Diane Fajmon - Environmental Assessment for the Inner West Light Rail Extension - Submission.

Application reference number: MP 10_0111

Response to the Submission to the Sydney Light Rail Extension - Stage One - Inner West Extension Environmental Assessment

Figure 2.1: Keeping the GreenWay within the shared corridor

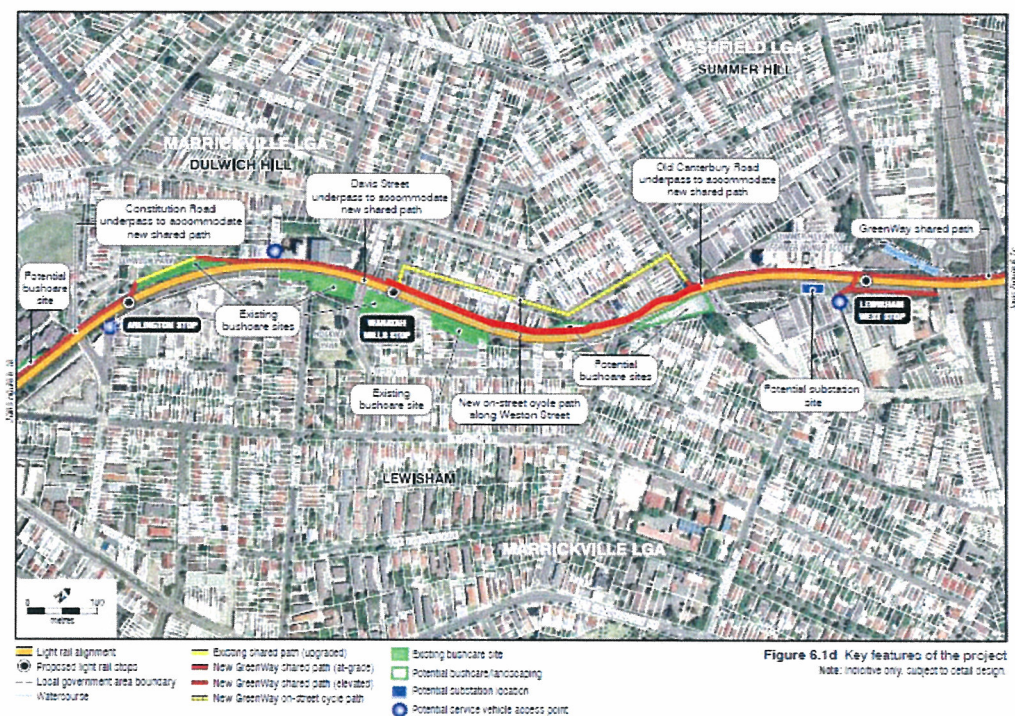
Looking at the map below, the GreenWay would continue as it currently is until Weston Street (i.e. red unbroken line), instead of detouring as presently recommended (yellow unbroken line).

Figure 2.2: GreenWay cross-section showing Alternative 1

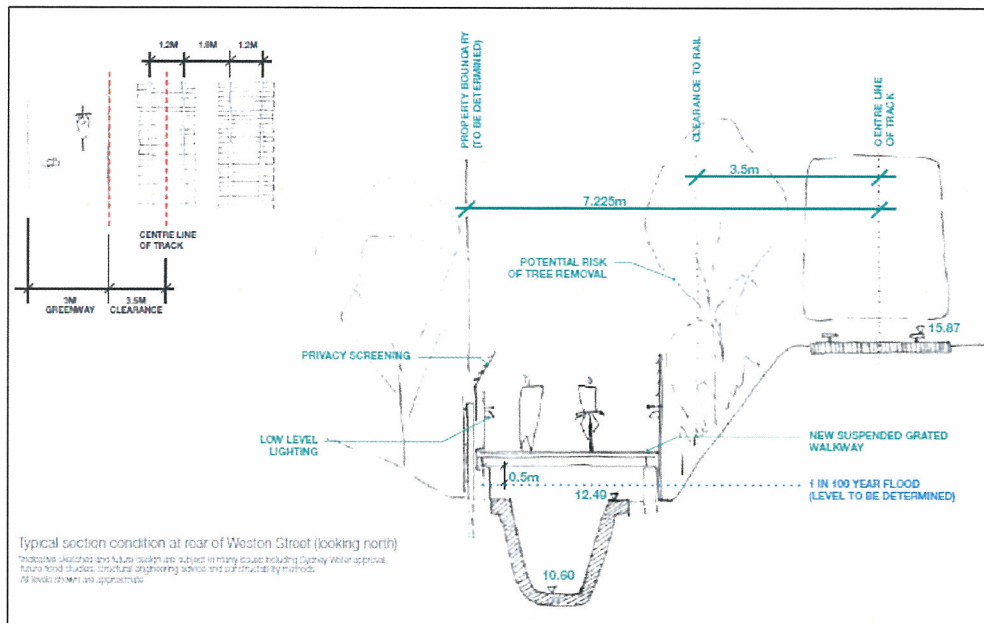
Given the sightlines displayed in the diagram below, we question why it was not mentioned that the light rail operation has a similar impact. Further, it seems clear that this can be easily rectified, yet this advice was not provided either.

Further, we believe that the impact of having it in the light rail corridor is far more easily ameliorated than having it detour down the front of those same houses. Screening vegetation, in addition to the safety screen built on the GreenWay, should be able to protect residents and provide a level of safety/security as well (which was the other resident’s concern). TNSW would also be able to raise the fences of residents affected

Figure 2.3: Proposal 2 access routes

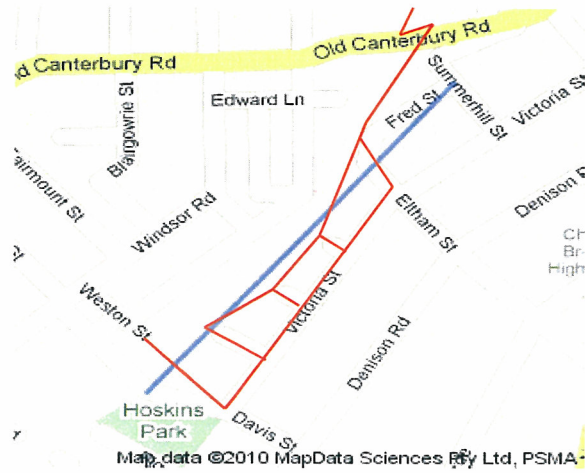
All these exit points would lead to the GreenWay being diverted down a shorter distance of residential streets decreasing the impact on residents and increasing safety. Victoria Street is equally as wide as Weston Street and is already a designated cycleway, which supports its credentials as an alternative. Davis Street overpass is also an existing cycleway, which gives further weight to the argument that this must be considered as a viable alternative. Victoria Street also has existing 'safety humps' in place to increase safety by slowing traffic.

With this alternative there are no GreenWay road crossings and no GreenWay crossings at the rail level making this a safe and viable alternative. Furthermore, fewer Victoria Street residents back directly onto the rail corridor than in Weston Street, so they will only be affected by the Greenway and not by the visual and noise implications from the light rail.

Figure 3.3: Access points for Arlington B

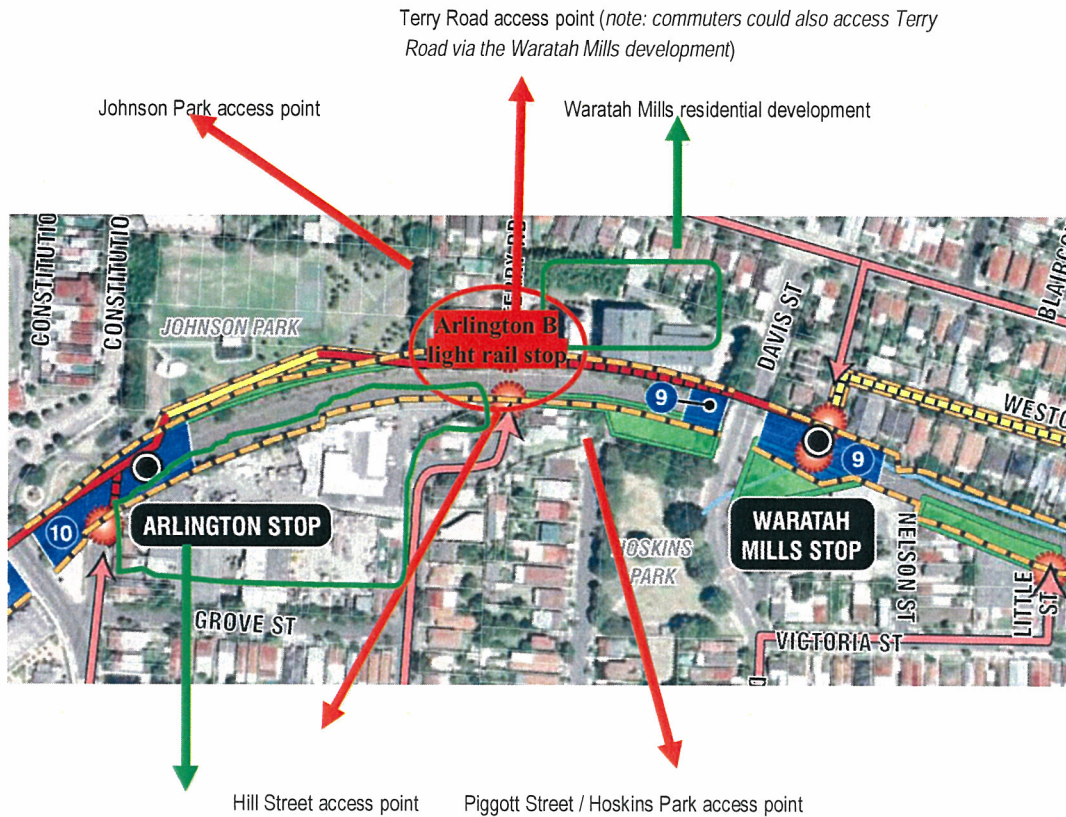
Arlington B would provide up to four (4) at-grade pedestrian and cycle access points as follows:

Each of these access points is shown on the diagram below, together with the location of the current Arlington and Waratah Mills stops as proposed by TNSW. The red oval indicates the location of Arlington B, consolidating the Waratah Mills and Arlington stops.

Figure 3.6: Light rail catchment areas with Arlington B only

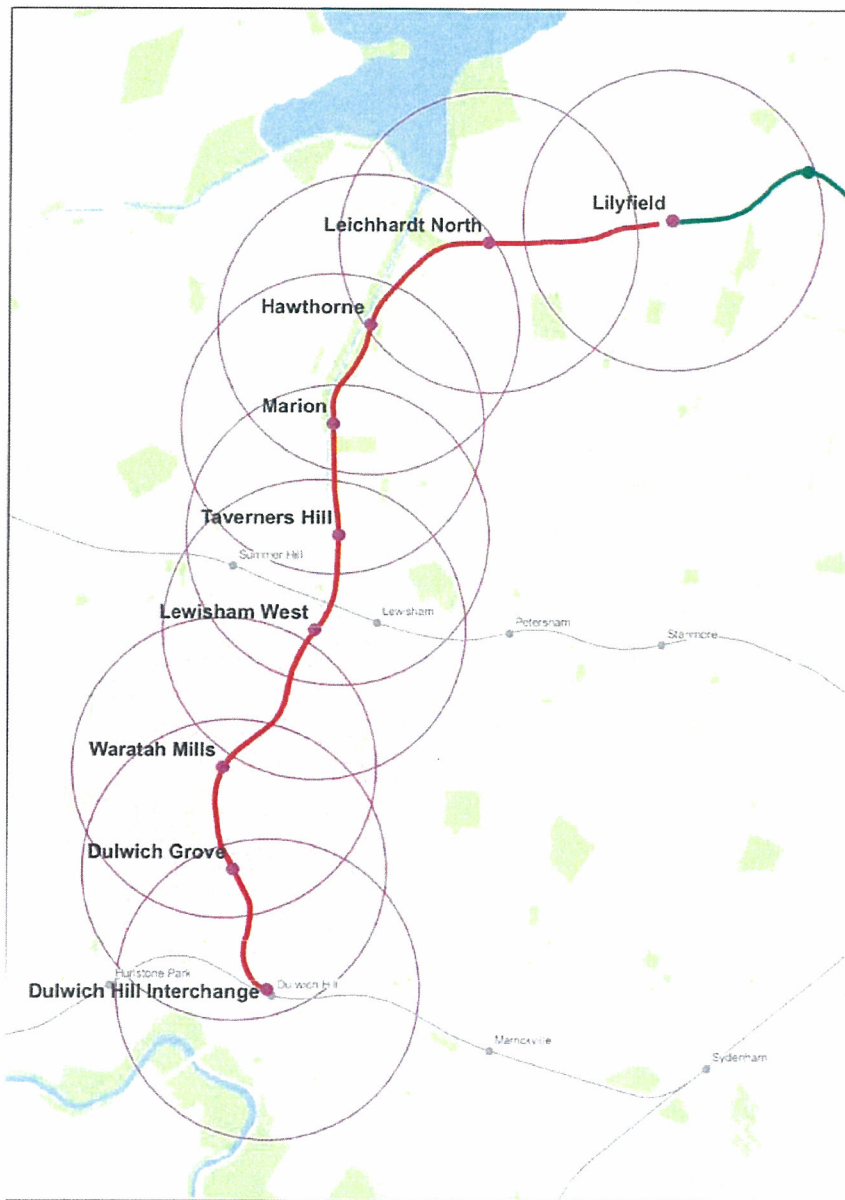
The diagram below demonstrates that consolidating the Arlington and Waratah Mills stops into one Arlington B stop will have a negligible impact on walk-up catchment.

Figure 3.7: Arlington B patronage sources

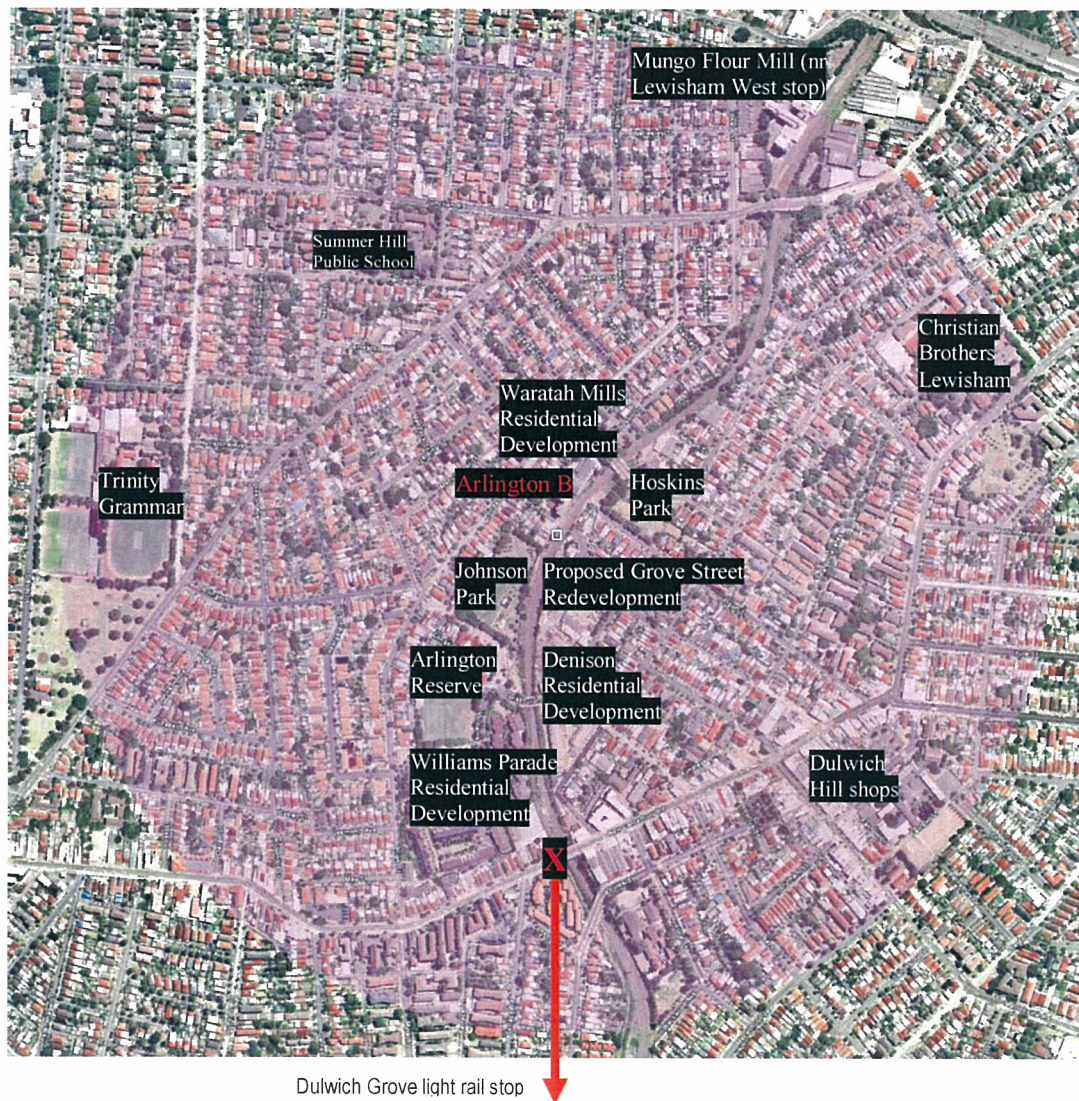
The aerial photograph below shows places of interest and sources of patronage that will remain within the light rail catchment as well as the location and, therefore the proximity, of the Dulwich Grove and Lewisham West light rail stops, which will be respectively south and north of Arlington B.

In summary, Arlington B will continue to provide excellent commuter access whilst simultaneously improving overall light rail operating speeds and efficiency.

Figure 3.10: Arlington bush care loss

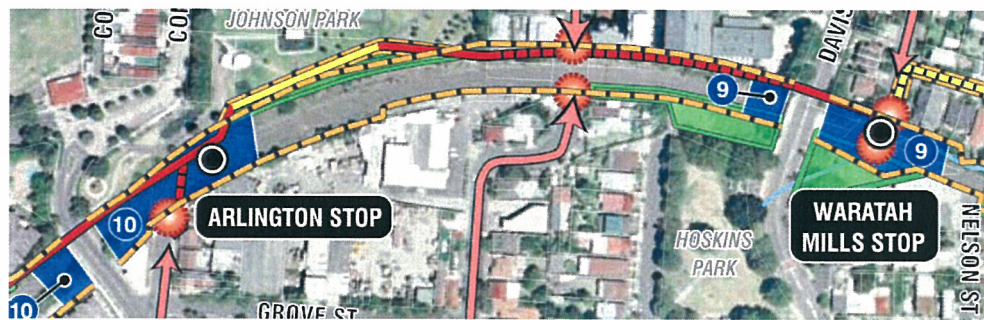
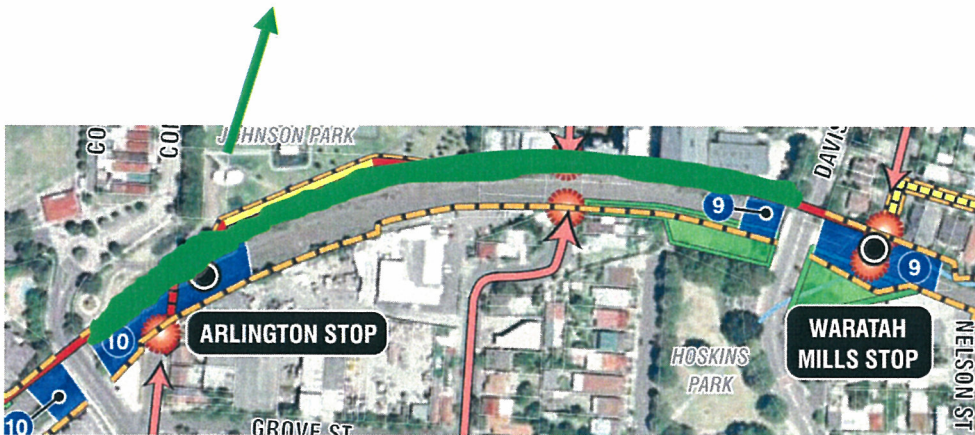
The map fails to show, however, that the Waratah Mills bush care site actually extends along the entire western border of the rail corridor between Constitution Road and Davis Street. Thus the impact of the Arlington stop on bush care is under-reported.

Figure 3.11: Waratah bush care loss

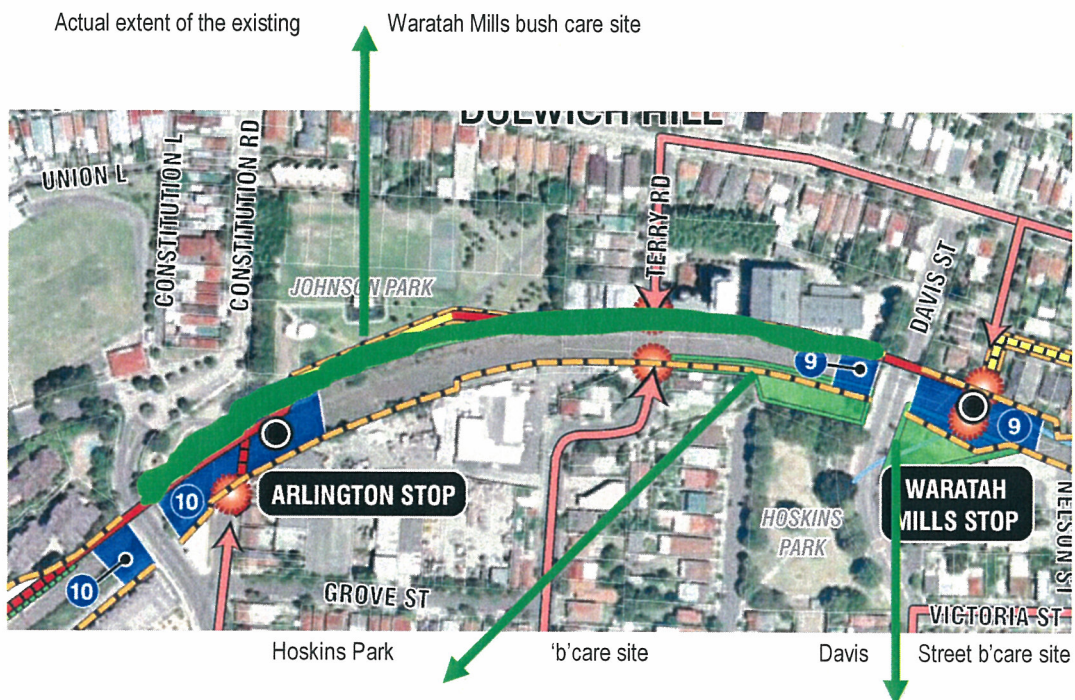
The significant advantage of the Arlington B site is that service vehicle access to the light rail track could be achieved via the cul-de-sac portions of Weston Street and Constitution Road, which are not bush care sites. Also, Terry Road is already being used by the construction teams to access the light rail track. This area of bush care has, therefore, already been destroyed. The Arlington B stop could be constructed over this already destroyed area of bush care which will, overall, minimise further bush care destruction.

Figure 3.14: removal of TNSW-proposed access points, introduction of alternative

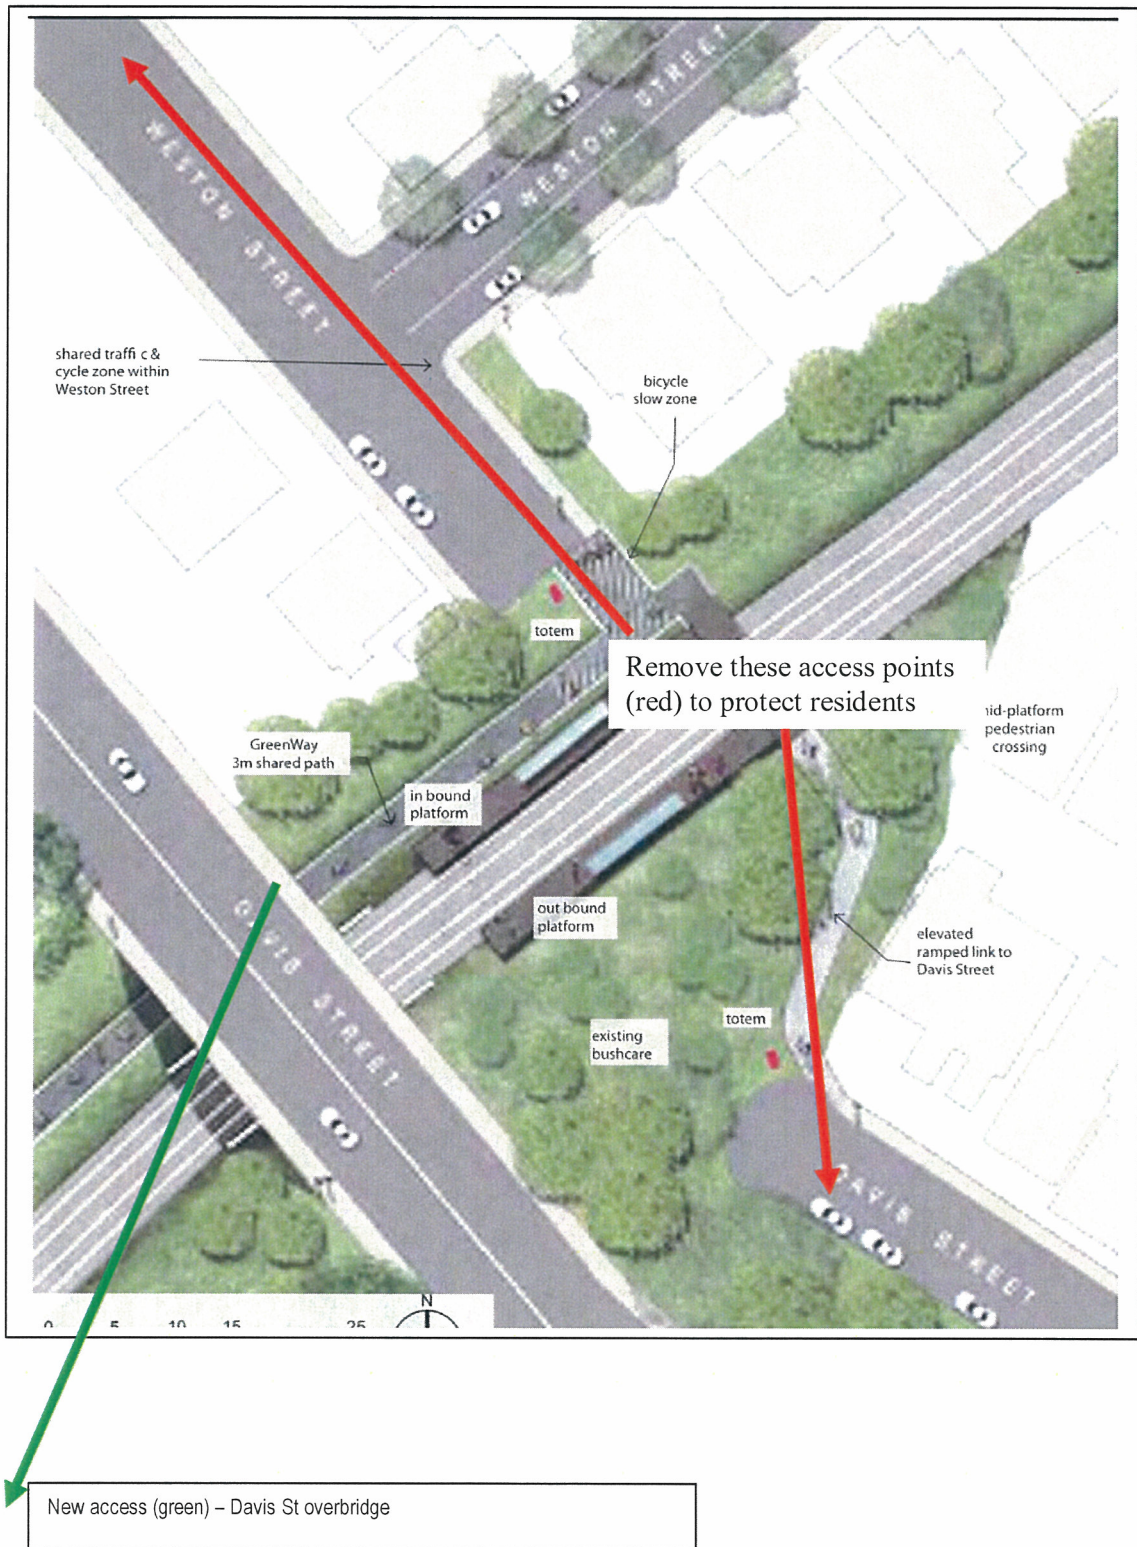
We suggest moving the Weston and Davis Street cul-de-dac access points and introduce screening planting to minimize the intrusion to residents (aka 'sensitive receivers'). See figure 3.14 below for details.
